GFA AIRWORTHINESS DIRECTIVE

- TYPE AFFECTED:** GROB ASTIR CS. Type Cert 306. Ser No's 1001 up to 1536
- SUBJECT:** Horizontal stabilizer: Inspection & replacement of spherical head mounting bolt and collar bolts.

SERVICE BULLETIN MSB306-38/2

SERVICE BULLETIN NO. MSB306-38

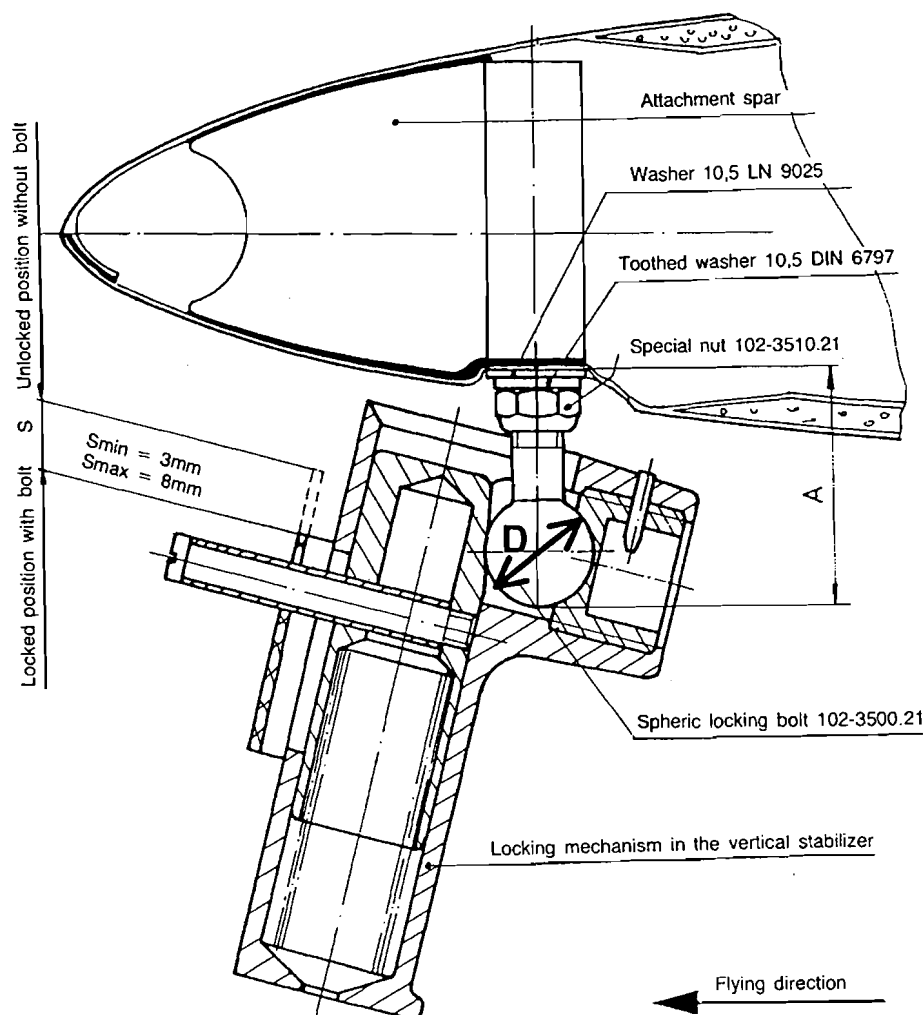
1.8.1 Check front and rear attachment of the stabilizer for noticable play before de-rigging the horizontal stabilizer. Therefore move the stabilizer at the tips carefully to all directions.

- if no play is noticed, perform further action according to para 1.8.2
- if play is noticed in the front attachment
 - the spherical bolt must be replaced (see para 1.8.2). Determine the ball diameter. During order advise the measured diameter "D" + 0.1 mm.
- if play is noticed in the rear attachment
 - the retaining pins 102-2142.46 must be replaced (refer to Flight Manual ASTIR CS Chapter "Maintenance")
 - is further play noticable after replacement of the bolts, the bearings in the stabilizer spar web must be replaced (refer to Flight Manual ASTIR CS Chapter "Maintenance")

1.8.2 Inspect and replace the spherical locking bolt as follows:

- remove horizontal stabilizer according to the Flight Manual and lay down in a proper device
- determine and note the exact installation depth "A"

- loosen the hexagon nut P/N 102-3510.21 (14 mm wrench) and remove spherical bolt using a screw driver
- inspect the thread of the bolt (especially in the area nut/ socket) for cracks or damage (using magnifying glass x20 or dye penetrant testing)
- if a crack or any indication for crack starting is found, the bolt must be replaced immediately

- install the inspected or new spherical bolt, thereby pay attention for the correct installation depth
- tighten hexagon nut P/N 102-3510.21 with torque 20 Nm (tolerance +4, -2) holding the bolt using a screw driver
- install horizontal stabilizer
- check and adjust if necessary the stabilizer angle of incident according to the Flight Manual
